SERVICEGRAM

VOL. 4 NO. 1

What's Causing the Noise? Common Noise Complaints on Popular CUV, SUV and Pass Car Applications

Nylon insert

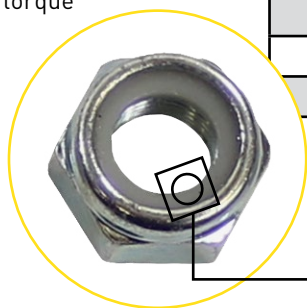
Noise issues related to new replacement ride control units on popular CUV, SUV and passenger car applications can be caused by distorted, threaded lock nuts. The lock nut design as well as manufacturing process is critical to noise-free performance for certain applications, noted in the chart below.

On these vehicles, if the nut is over crimped, it can be difficult to thread on the stem. This results in a gap between the rod and mount where the stem can move, often leading to unwanted noise.

Upgraded Nut with Nylon Insert Helps Prevent Noise

Most Monroe® Quick-Strut® assemblies feature a nylon insert to ensure the lock nut is completely threaded on the stem and in complete contact with the mount. This nylon insert provides a more consistent "prevailing" torque (amount of torque needed to run a nut down a thread) and requires less friction when threading the lock nut onto the stem. The result: a completely threaded nut.
